ADDENDUM NO. 2

BID NO: R169150

COMMODITY: RFP/VW Closure Line Revisions

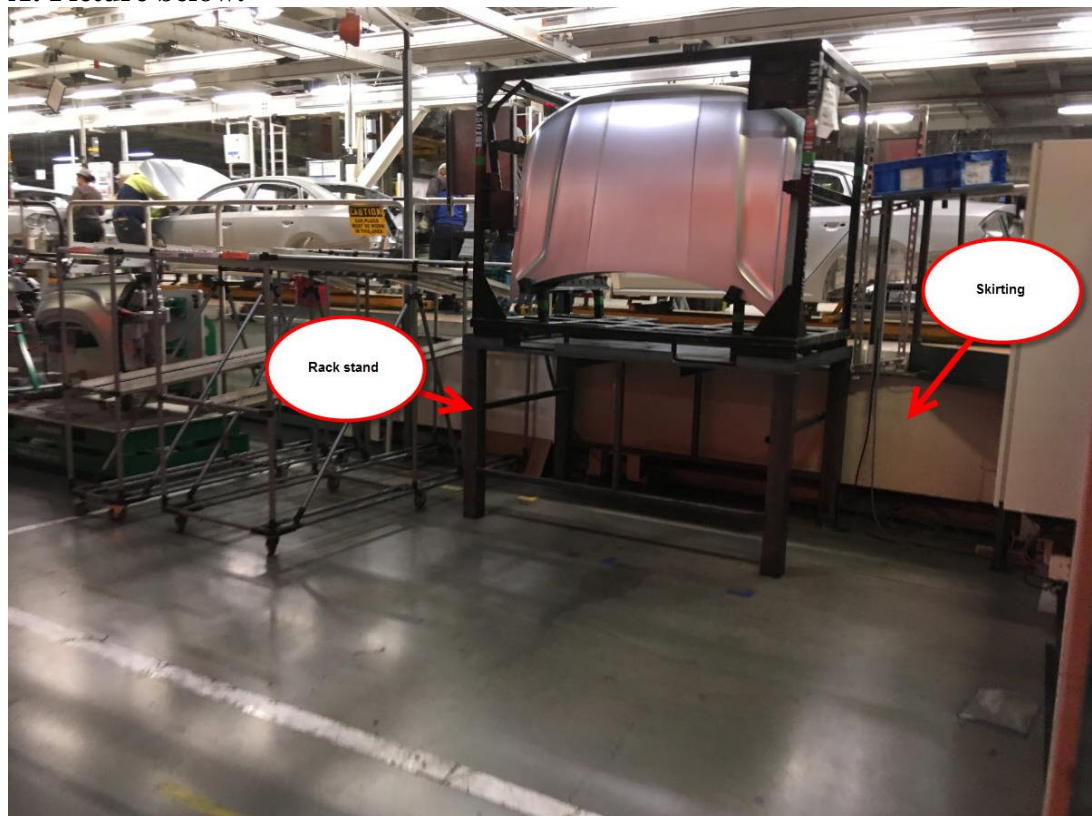
1. **Q:** Can you please provide me a picture or two of the logistic rack stands and skirts on existing platforms?

A: Picture below.
